HUNTER'S COVE SUBDIVISION, **UNIT FOUR, PHASE TWO**

APPLICATION NUMBER 16 DATE September 20, 2007

APPLICANT Hunters Cove Subdivision, Unit 4, Phase 2

REQUEST Subdivision

DETAIL SITE PLAN

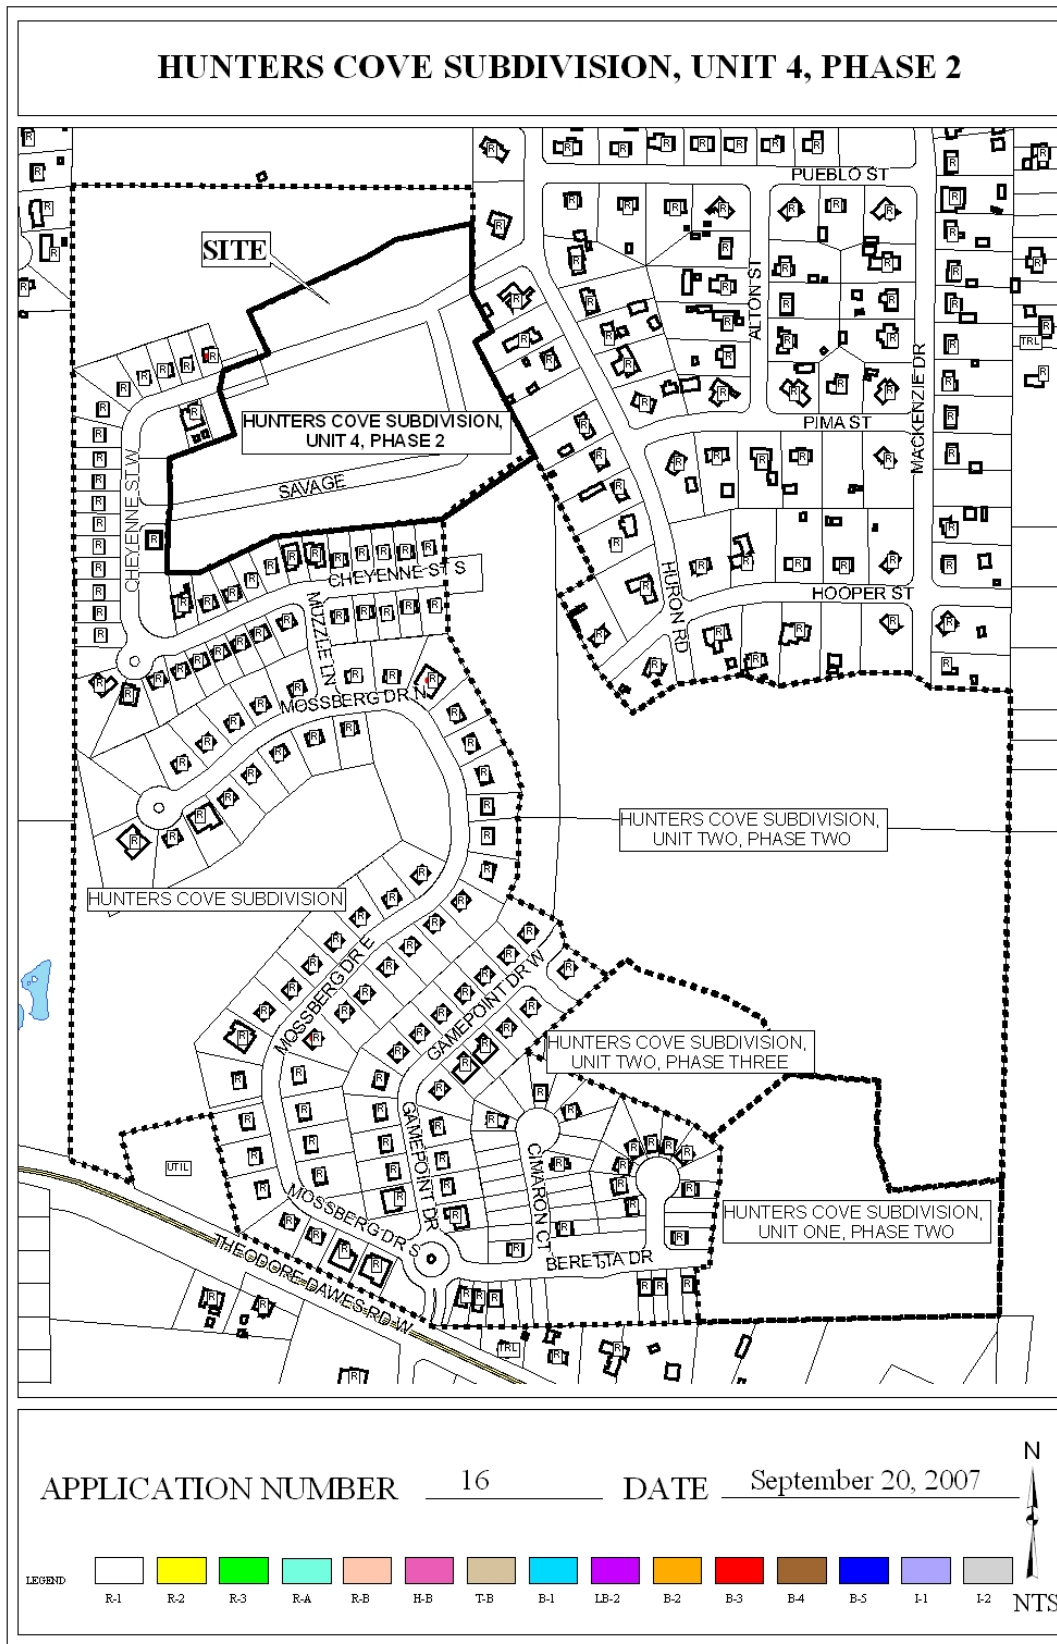
The new roads for the site are to be dedicated and constructed to meet County Engineering Standards. Additionally, since Lots 54, 58 and 87 are corner lots; a note should be placed on the Final Plat stating that Lots 54, 58 and 87 are limited to one curb-cut each with the size, design and location to be determined by County Engineering.

One common area is depicted and labeled on the preliminary plat, as is a note stating that maintenance of any common areas will be the responsibility of the development's property owners association: This note should also appear on the Final Plat, if approved.

The "General Notes" portion of the preliminary plat identifies various utility and drainage easements, which should also be graphically depicted on the drawing.

This site is located in Mobile County and labeled on the preliminary plat, a note stating that any lots which are developed commercially and adjoin residentially developed property must provide a buffer, in compliance with Section V.A.7. of the Subdivision Regulations. This note should also be placed on the Final Plat, if approved.

The site is in the unincorporated part of Mobile County; nevertheless, development should be designed to comply with the stormwater detention and drainage facilities of the City of Mobile stormwater and flood control ordinances. Submission of certification from a licensed engineer prior to signing of the Final Plat or commencing of any land disturbance activities certifying that the design complies with the stormwater detention and drainage facilities of the City of Mobile stormwater and flood control ordinances prior to the issuance of any permits should be required. Certification should be submitted to the Planning Section of Urban Development and County Engineering.

- 1) the placement of a note on the Final Plat stating that Lots 54, 58 and 87 are corner lots be limited to one curb cut with the size, design and location to be approved by County Engineering;

- 2) retaining of common area labeling, labeling of lot sizes and notes;
- 3) graphic depiction of all drainage and utility easements referenced in the "General Notes" section;

- 4) placement of a note on the Final Plat stating that any lots which are developed commercially and adjoin residentially developed property must provide a buffer, in compliance with Section V.A.7. of the Subdivision Regulations; and

- 5) placement of a note on the Final Plat stating that development will be designed to comply with the stormwater detention and drainage facilities of the City of Mobile stormwater and flood control ordinances, and requiring submission of certification from a licensed engineer prior to signing of the Final Plat or commencing of any land disturbance activities certifying that the design complies with the stormwater detention and drainage facilities of the City of Mobile stormwater and flood control ordinances prior to the issuance of any permits. Certification to be submitted to the Planning Section of Urban Development and County Engineering.
